Memorandum to the City of Markham Committee of Adjustment

File: A/215/22
Address: 16 Cachet Parkway, Markham
Applicant: Monica Nijhawan
Agent: CS&P Architects Inc. (Sam Spagnuolo)
Hearing Date: Wednesday, February 1, 2023

as it relates to a proposed two-storey detached dwelling.

SITE PLAN

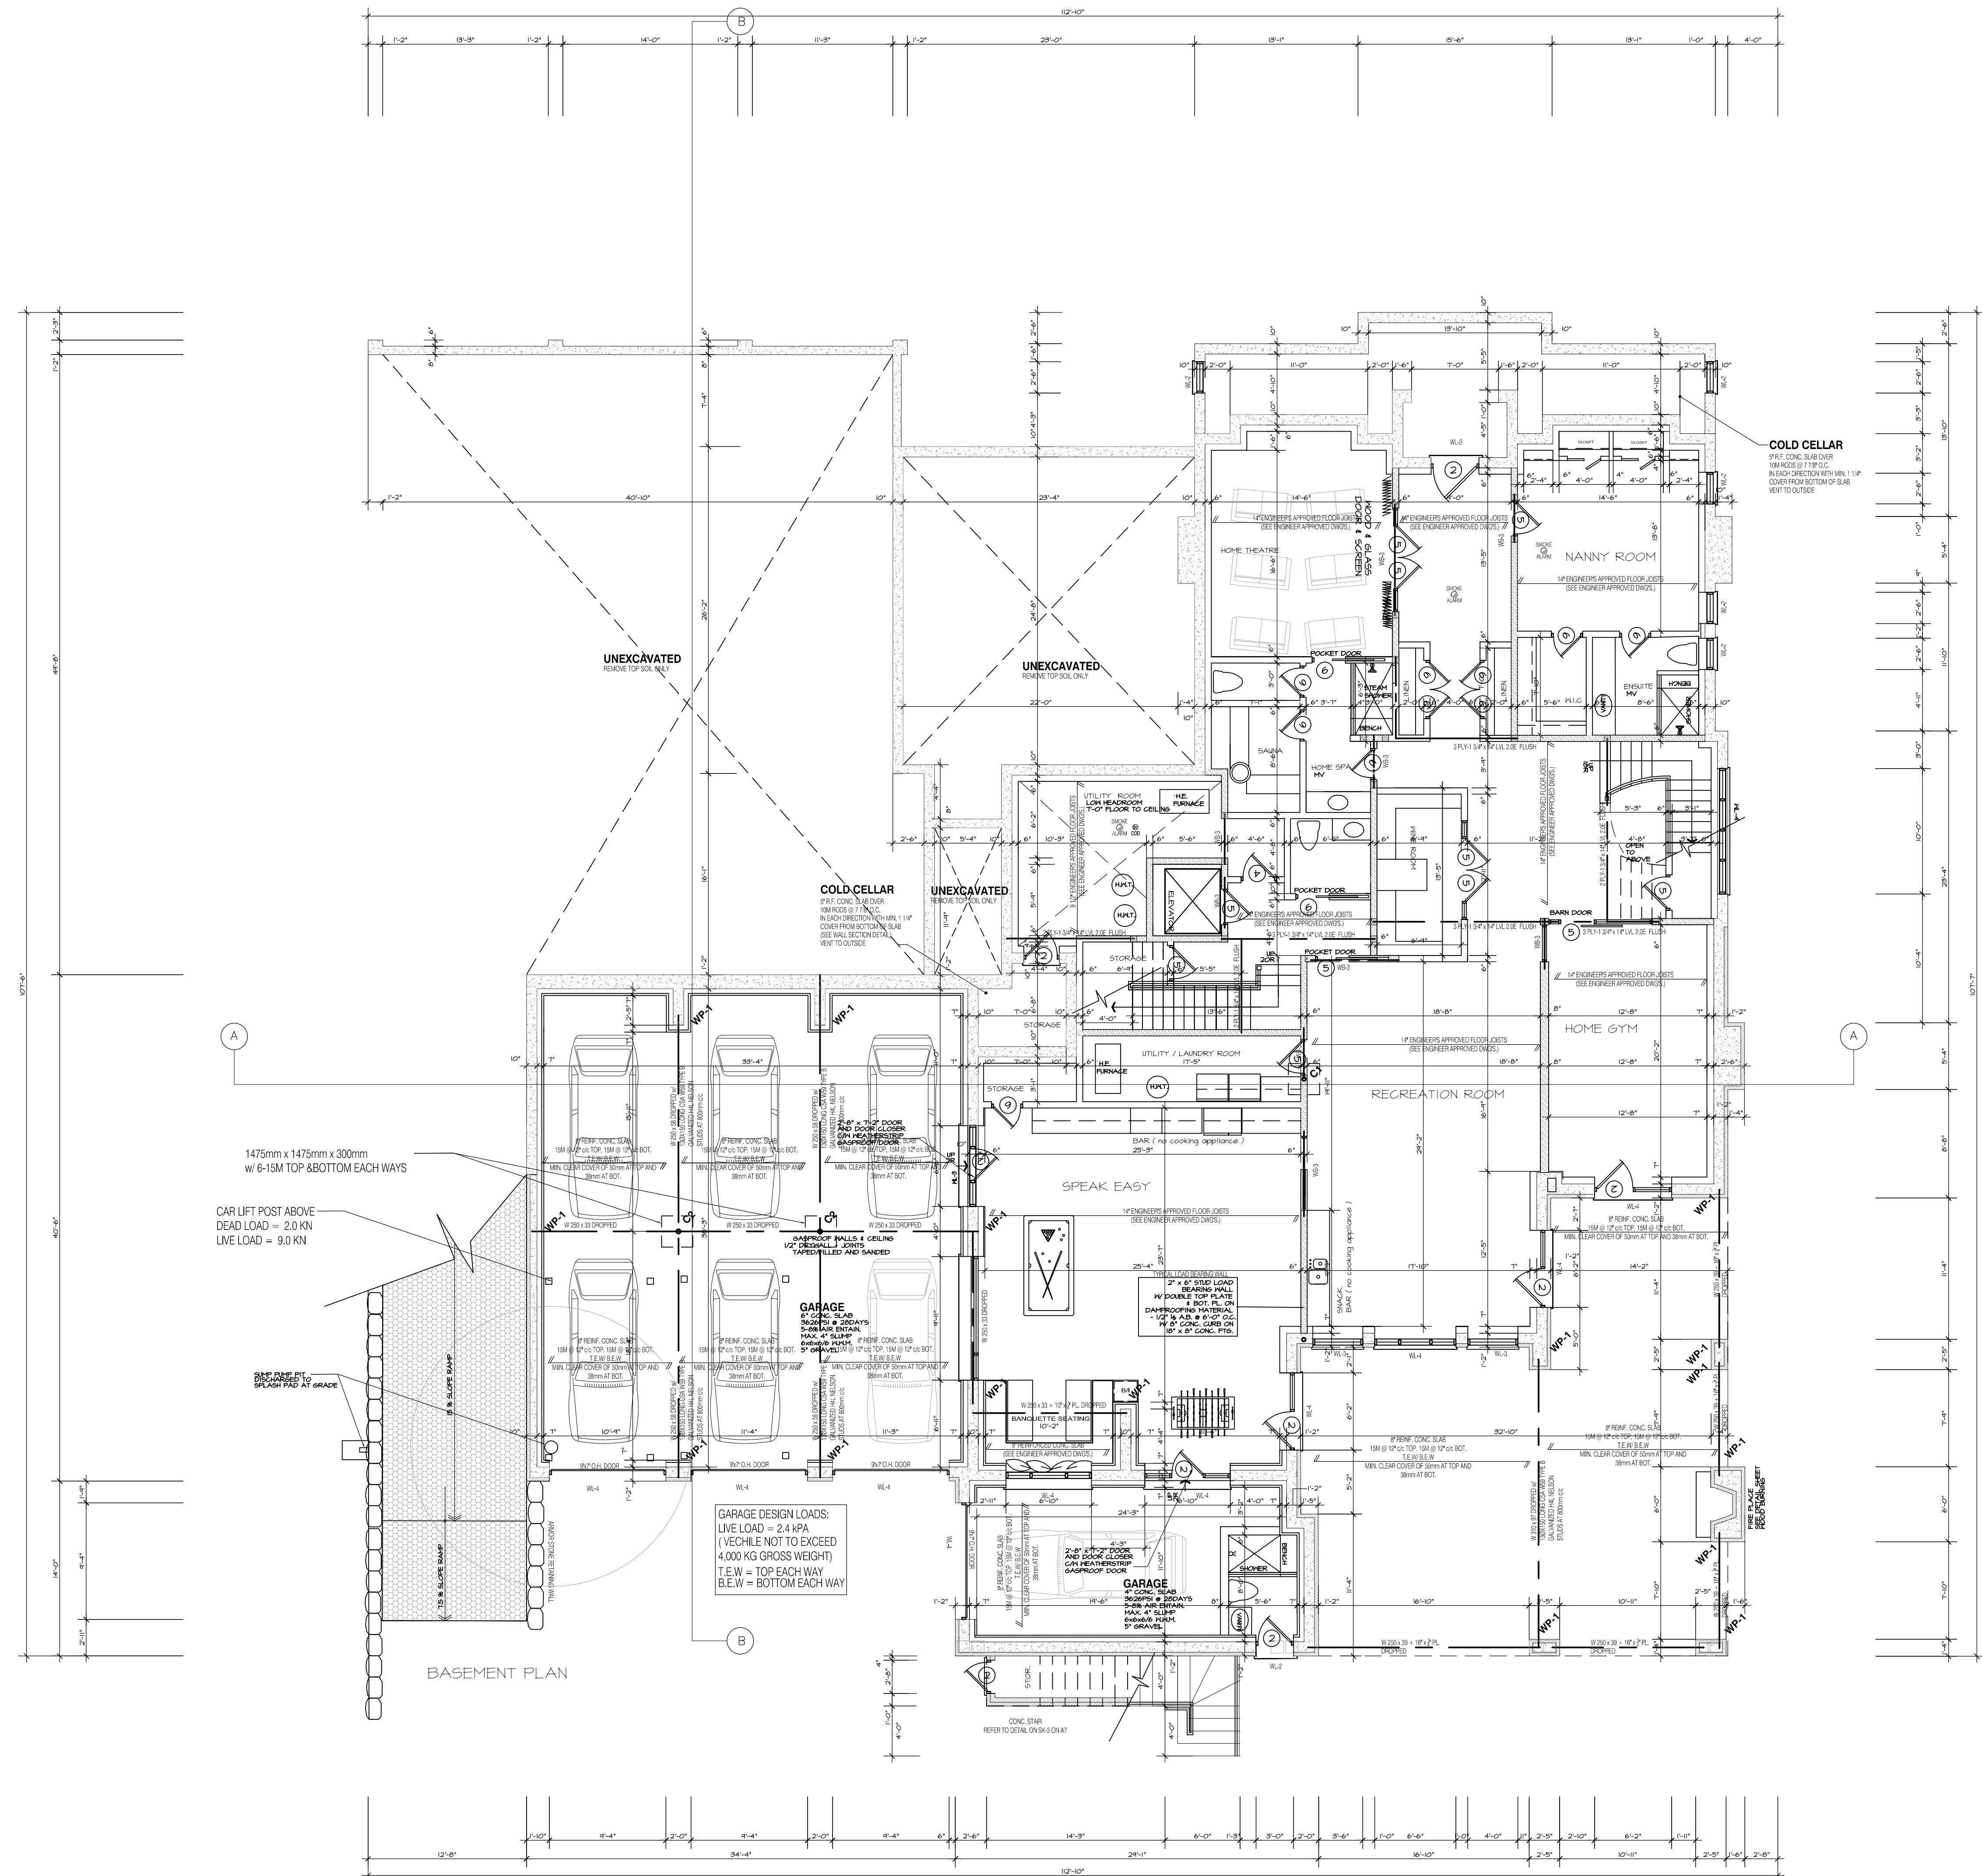
Staff note that the proposed driveway has a width of 18 m (59.08 ft), whereas the City's Parking By-law 28-97 only permits the driveway width to be 6.1 m (20 ft), provided a minimum 40% soft landscaping is provided in the front yard.

The requested variance seeks to permit a single vehicular access onto Cachet Parkway, which leads into an internal circular driveway. In addition, the applicant's architect has indicated that the front yard proposes to maintain 61.41% of soft landscaping in the front yard. The variance would not detract from the streetscape.

The applicant is requesting a minimum 2.378 m (7.83 ft) side yard setback, whereas the by-law requires a minimum side yard setback of 3.0 m (3.85 ft). In addition, the applicant is requesting a minimum of 8.35 m (27.4 ft) for the sum of both side yards, whereas the By-law requires a minimum of 9.0 m.

Engineering staff have reviewed the application and have no concern with the variance respecting drainage.

The applicant is requesting relief to permit a private driveway leading to a private garage to have a floor elevation lower than the elevation of the public street, whereas the by-law requires a private driveway leading to a private garage to have a floor elevation higher than the elevation of the public street.

By-law 28-97, as amended, requires that the garage floor elevation be above the elevation of the public street, in order to prevent “reverse” or “negative” slope driveways. The only exception to this is a case where the first floor of the dwelling is lower than the level of the street due to natural topography, in which case a garage floor may be 1.0 metre lower than the first floor of the dwelling. In this instance, the above exception does not apply, since the dwelling’s first floor elevation is higher than the elevation of the public street.

Planning staff generally do not support reverse slope driveways. The flooding of dwellings has been a growing problem in many parts of Markham, and reverse slope driveways can be a significant contributing factor. With reverse slope driveways, catch basins that drain the driveway are at a lower elevation in relation to the road. However, in this instance Engineering staff are of the opinion that the requested variance does not present a flooding issue given the larger lot size.

DRAWING TITLE:
 ELEVATIONS

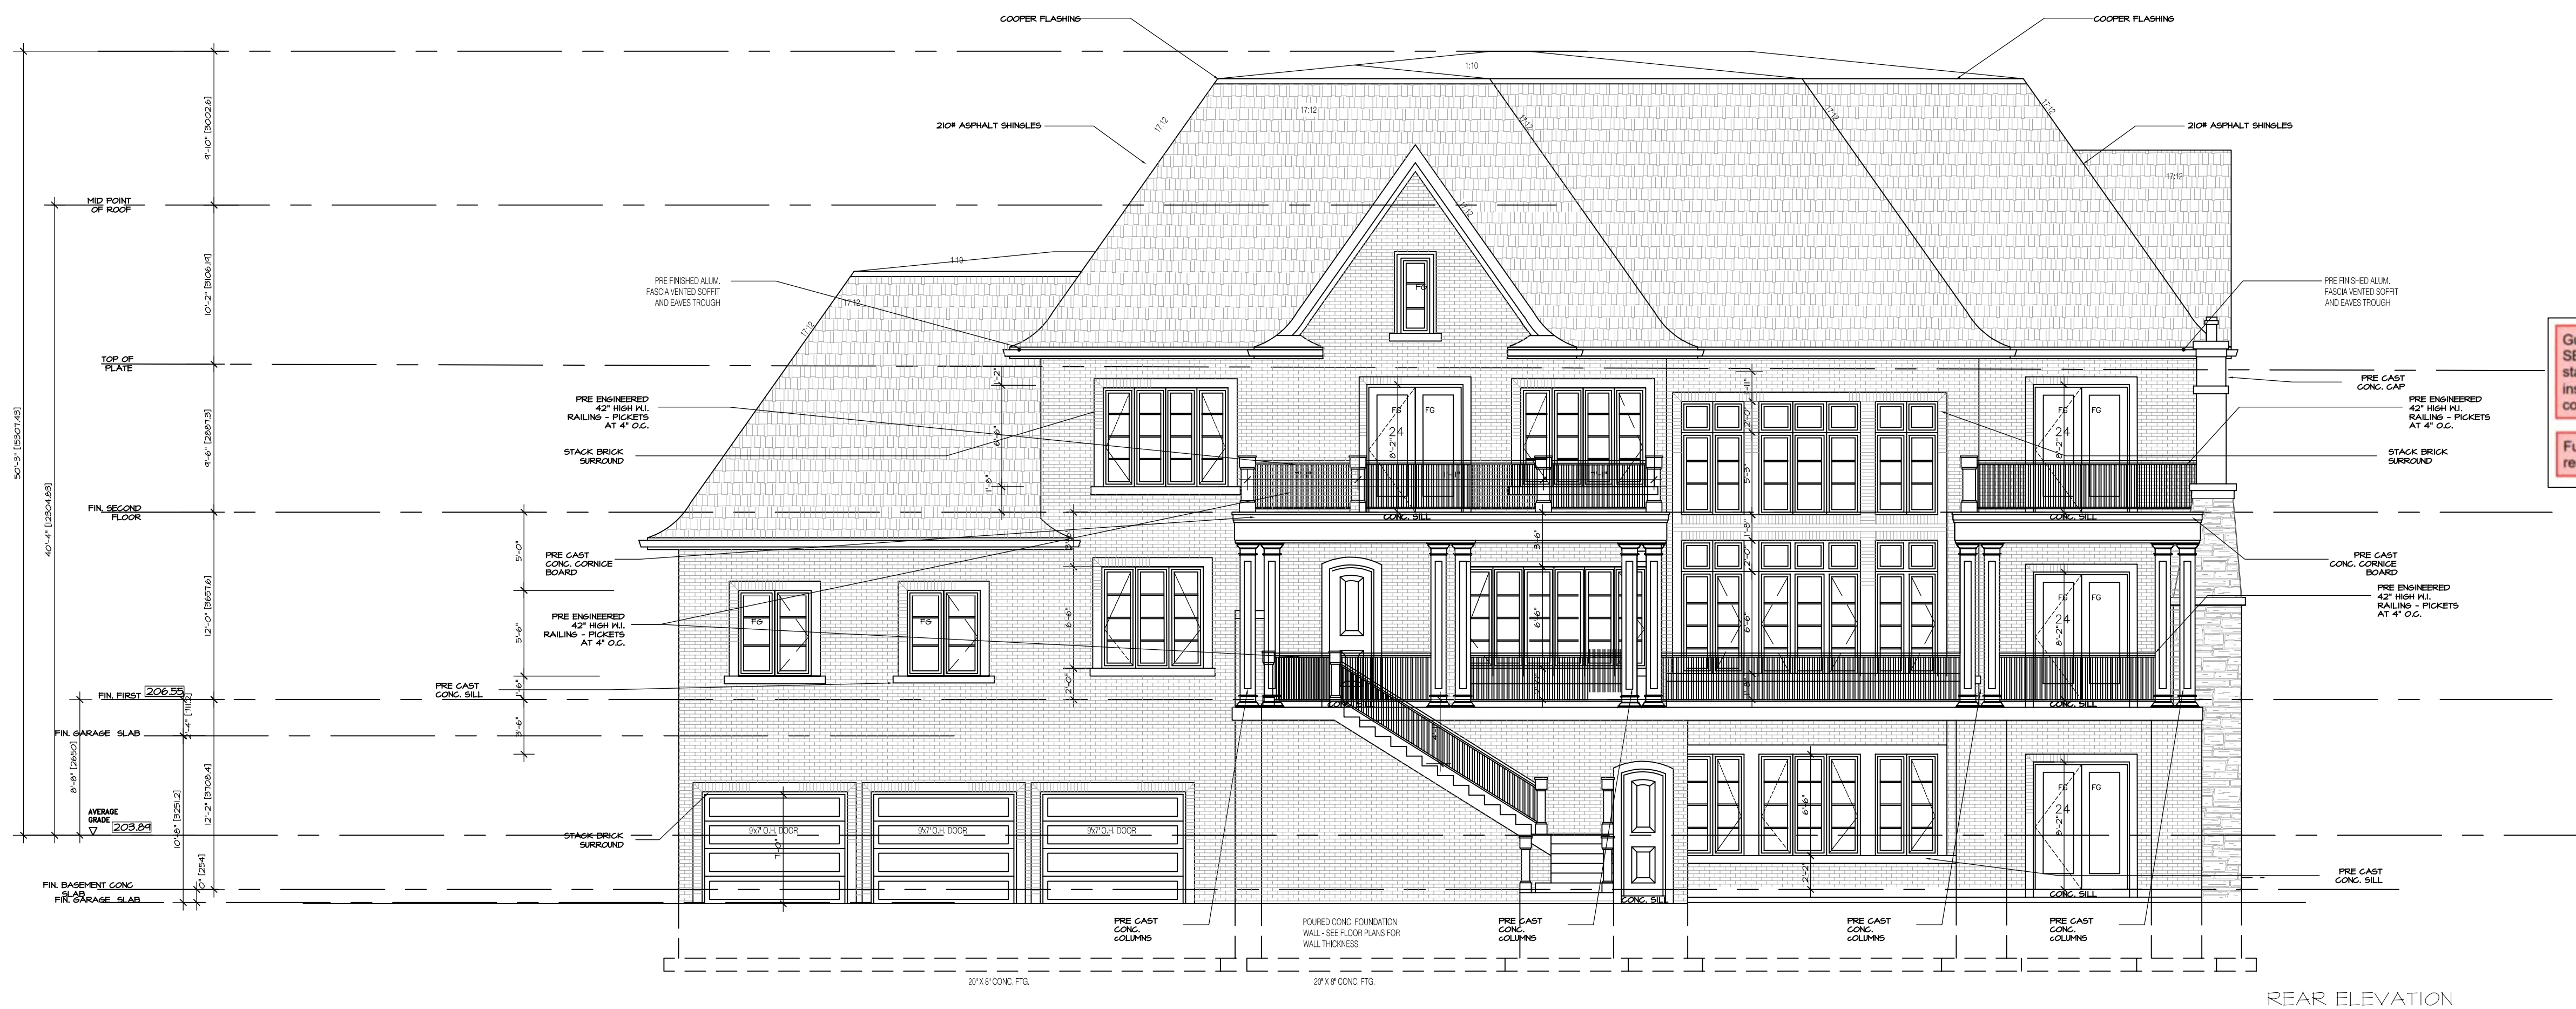
The applicant is requesting relief to permit a maximum building height of 12.31 m (40.39 ft), whereas the By-law permits a maximum building height of 10.7 m (35.1 ft). This represents an increase of 1.61 m (5.28 ft), or 15%.

The By-law calculates building height using the vertical distance of building or structure measured between the established grade and the mean level between eaves and ridge of a gabled roof.
